California High-Speed Train Project

Agreement No.: HSR 13-06
Book 3, Part D, Subpart 5

Design Variance Report

DESIGN VARIANCE COVER SHEET

Clinton Ave - Exhibit 7

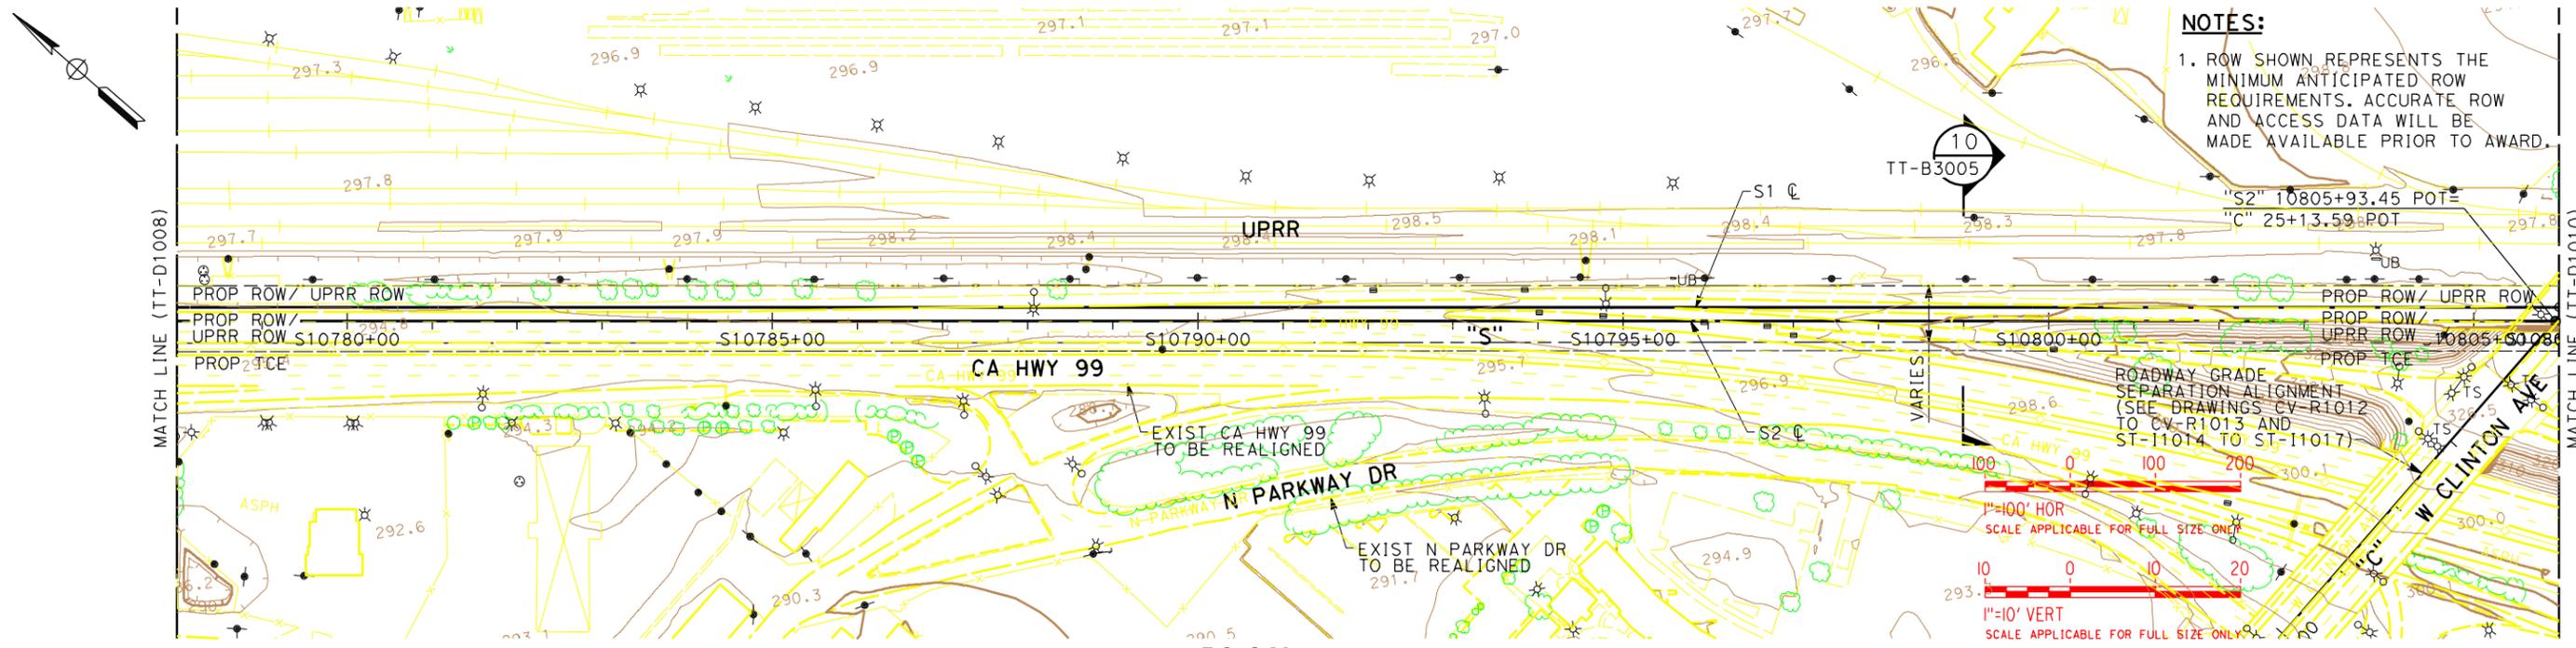
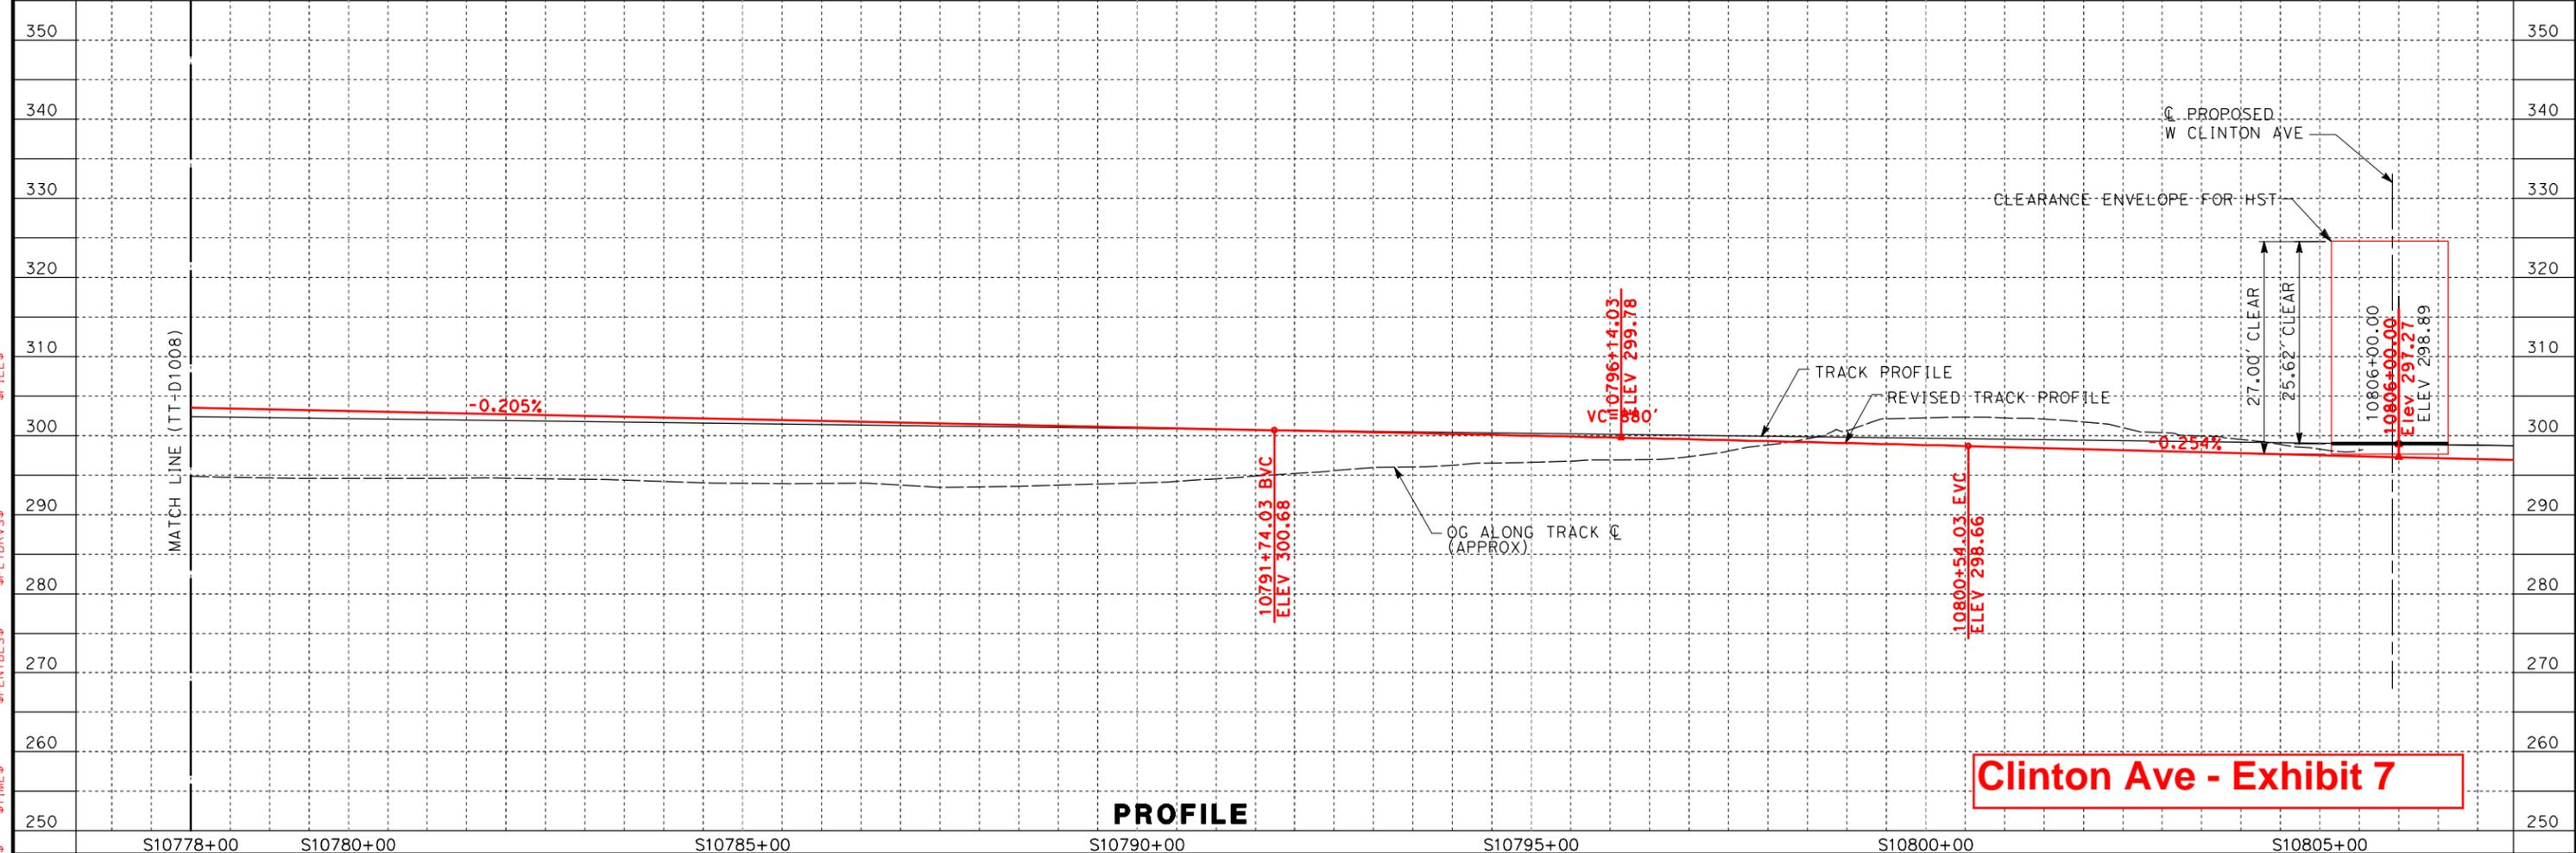
<p>used to meet the flood elevation requirements.</p> <p>Current draft 30% roadway design, as shown in Exhibit 4 is based on current mapping. It should be noted that as a result of the poor accuracy of the initial mapping (+/- 3 ft accuracy), lower clearance was discovered when using the updated mapping. The current draft 30% design has already adjusted the roadway profile and HST profile to provide additional 1 ft clearance due to the initial mapping accuracy issues.</p> <p>Subsequent evaluation and adjustment of the 30% profile design were conducted based on :</p> <ul style="list-style-type: none"> • Updated mapping (+/- 0.5 ft accuracy) • Estimated flood elevation requirement <p>Based on FEMA evaluations and maps, 100 year flood event will impact regions near San Joaquin River, Herndon Canal and south of Clinton. <u>Local area adjacent to Clinton Ave. is therefore subject to only localized flooding for which flood agencies use 6 inch water elevation above existing ground/Golden State Blvd..</u> At Clinton crossing, existing ground is at 297.5 ft. Allowing for 0.5 flood elevation (i.e. elevation 298), TOR at 2.5 ft higher will be at minimum elevation of 300.5 ft.</p> <p><u>A track profile with 24 ft clearance below the Clinton overhead structure, will meet flood elevation requirements with no need for boat section.</u></p> <p><u>C-DVR 25.5 ft clearance, w/ 1.5 ft deep Wall/Boat Section</u></p> <p>The draft 30% HST track profile design shown in Exhibit 4, provides for an intermediate option of 1.5 ft higher 25.5 ft clearance over HSR tracks, by lowering the profile.</p> <p><u>The estimated flood elevation will impact the current 30% design with the DVR 25.5 ft clearance condition, requiring a 1.5 ft wall/boat section.</u></p> <p>As shown in exhibit 7, the draft 30% design HST profile (in black) will have TOR below minimum 300.5 ft level to clear flood elevation requirement, for nearly 1000 ft North of Clinton. This is primarily due to the HST profile adjustment required due to the initial mapping accuracy/errors. To meet flood elevation clearance requirements, it is proposed to consider wall/boat-section to protect track work</p>

Extract 1: TM 1.1.21 Rev 0 – Typical Cross Sections for 15% Design, Drawing C0303

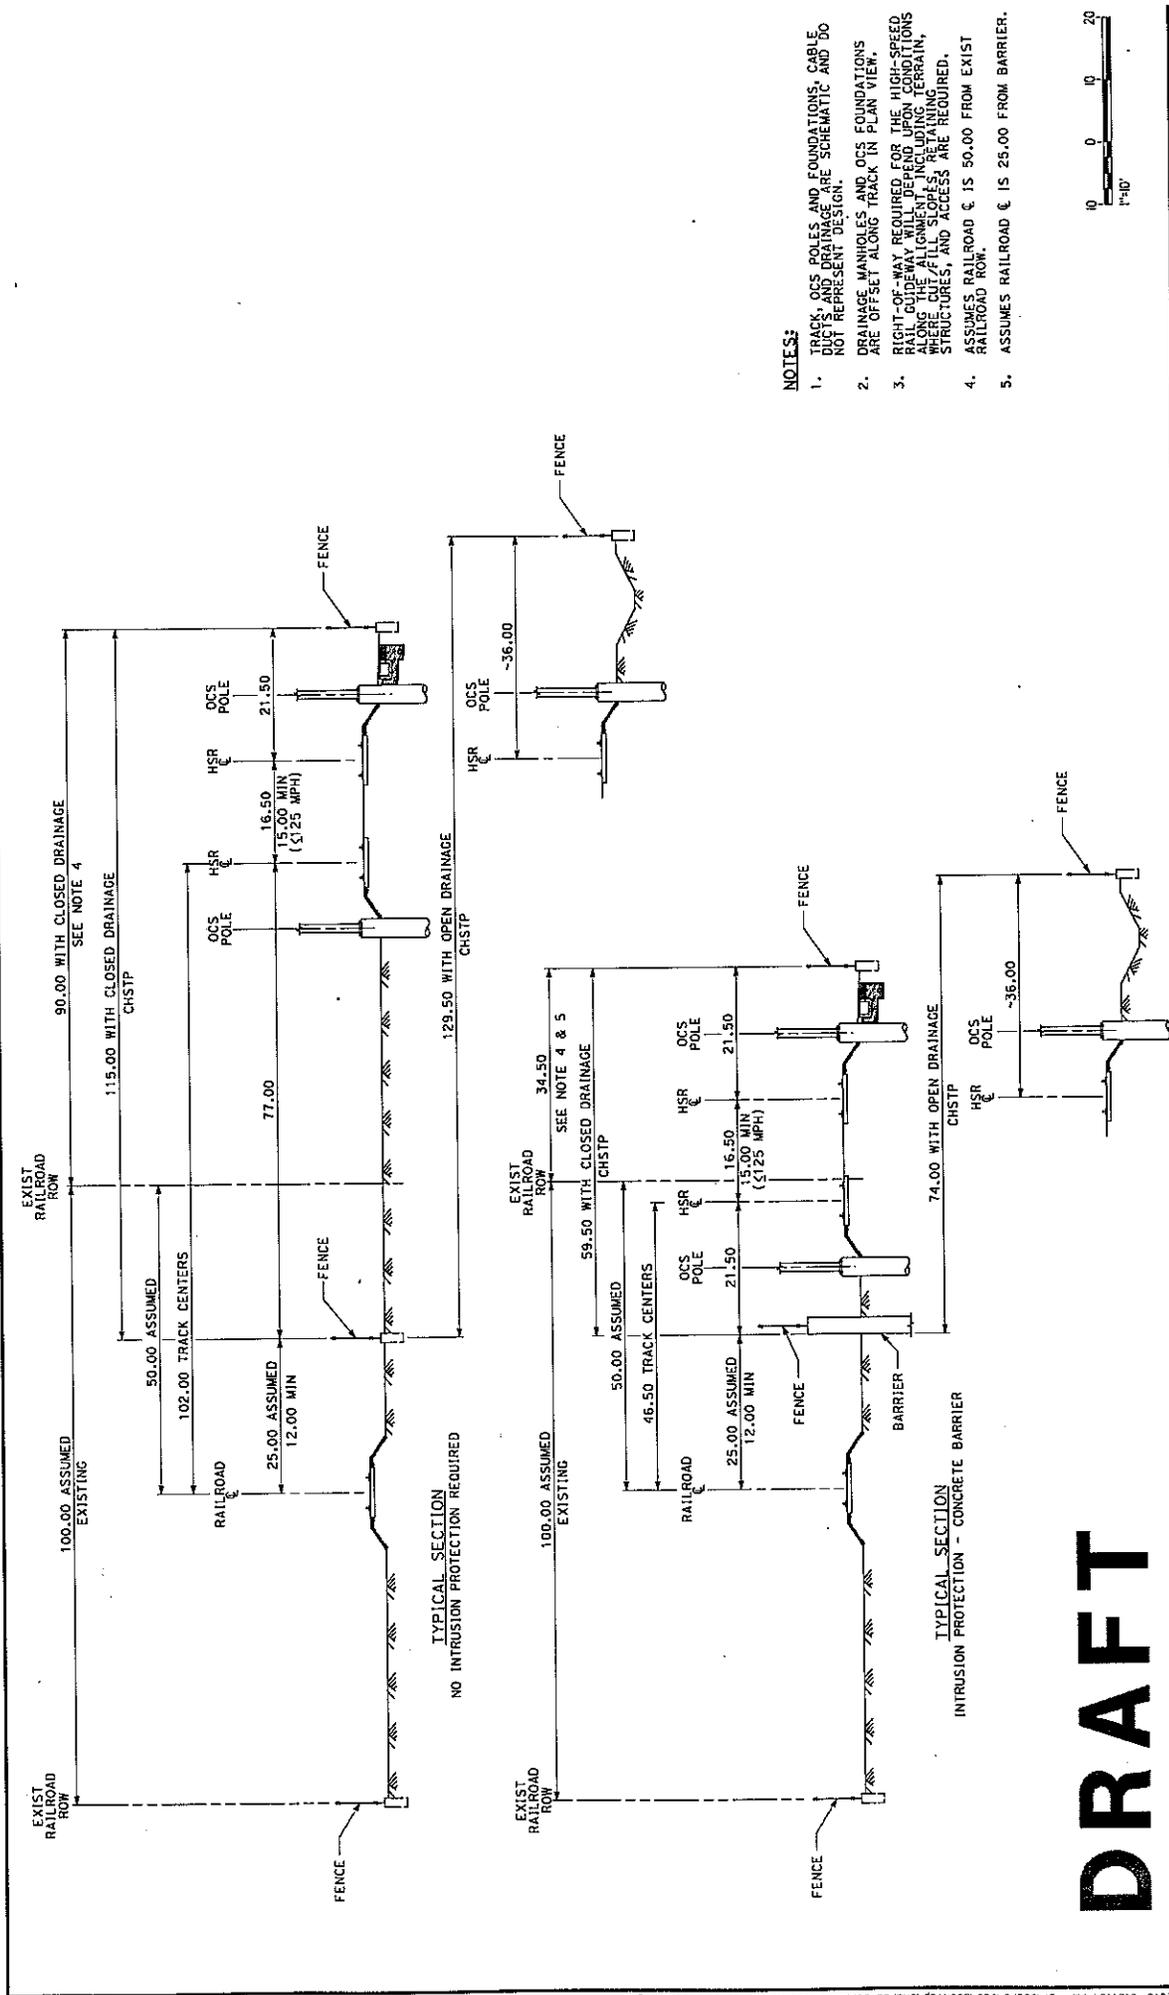
<p>SAFETY AND SECURITY</p>	<p>Safety of the HSR to be assured by means of derailment containment and intrusion protection. Security of the HSR to be assured by robust fencing and intruder alarm systems.</p> <p>The proposed configuration would not introduce any further safety or security risks beyond those that would be reasonably expected from locating the HST corridor adjacent to any other freight railroad. Drawing 3 in TM 1.1.21 and</p>

<p>Drawing 1 in The Memo identifies an intrusion protection barrier as close at 25ft from the nearest track.</p> <p>The current design meets the standards for separation of HST and all other railroad operators. Therefore it is understood that locating the HST ROW adjacent to the UPRR ROW, with an intrusion protection barrier, does not constitute a safety risk beyond the scenarios identified in the above standards.</p>
DIRECT COST	None identified
OTHER	Construction of the intrusion protect wall would need an access agreement with the UPRR. Alternatively the wall would need to be constructed from within the HST ROW.

Appendix B – Alignment Plan Layout and Cross-Section

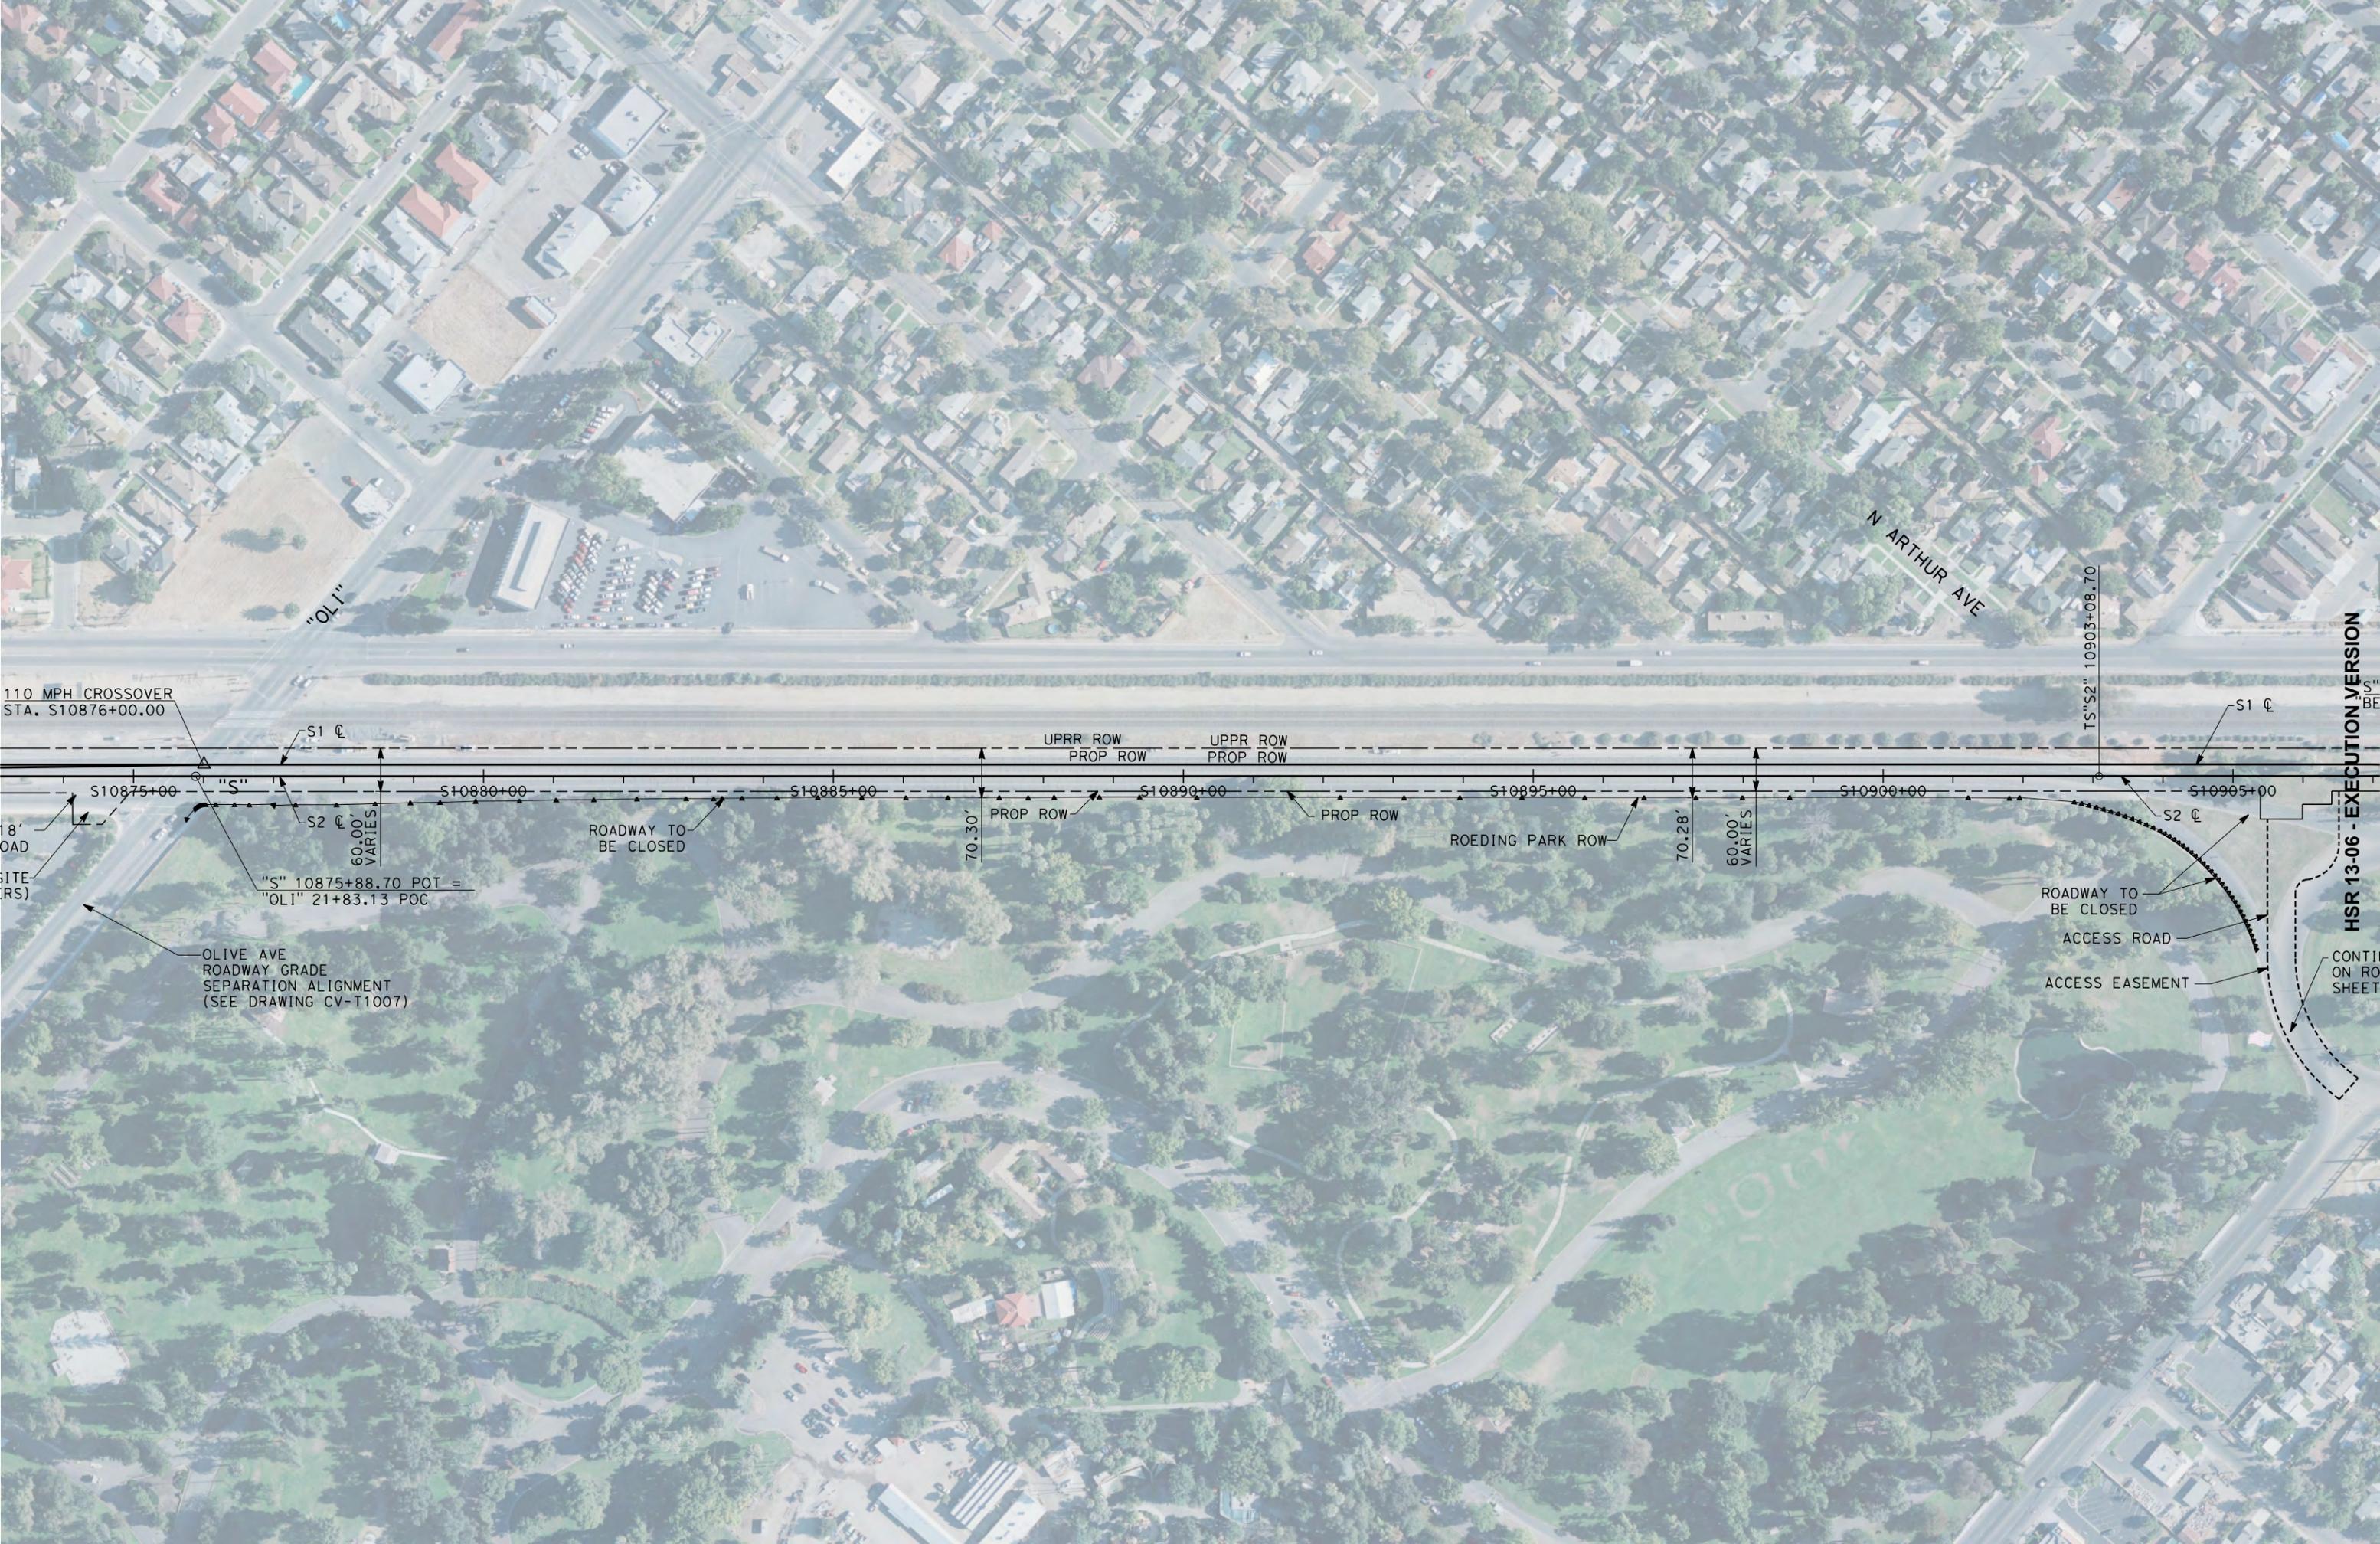
<p>CHSTP DESIGN REQUIREMENT Include reference to drawings, design criteria, technical memos, specifications</p>	<p>Memo dated 8/30/2010 – Clearances to conventional railroads, Union Pacific Railroad (UPRR) right-of-way (ROW), high-speed train (HST) bridge piers, and highways – TM reference number not available</p>
<p>DESIGN CRITERIA REQUIRING A VARIANCE</p>	<p>Memo dated 8/30/2010 – Clearances to conventional railroads, UPRR ROW, HST bridge piers, and highways (hereafter referred to as “The Memo”).</p> <p>Drawing 1 – HSR in shared corridor with UPRR at grade, in The Memo requires a minimum 12-foot separation between edge of UPRR ROW and face of derailment containment barrier. An extract is shown in Appendix A.</p>
<p>REASON FOR REQUESTING A VARIANCE</p>	<p>The constraints of State Route 99 and Roeding Park limit the corridor width available to HST.</p> <p>Between W Olive Avenue and E Belmont Avenue the HST corridor would be constrained by UPRR on the east and Roeding Park on the west. This location currently contains Golden State Boulevard which would be replaced with the HST corridor. Roeding Park is a Section 4(f) property and is not to be impacted by the footprint of the HST works. The available width between the UPRR ROW and Roeding Park boundary is 70ft. The available width does not allow for a 60-foot wide HST corridor with a 12-foot separation to the UPRR ROW. Achieving the 12-foot separation to UPRR ROW would require either intrusion into Roeding Park or the UPRR ROW, or a substandard HST ROW width. A layout of the design is shown in Appendix B.</p>
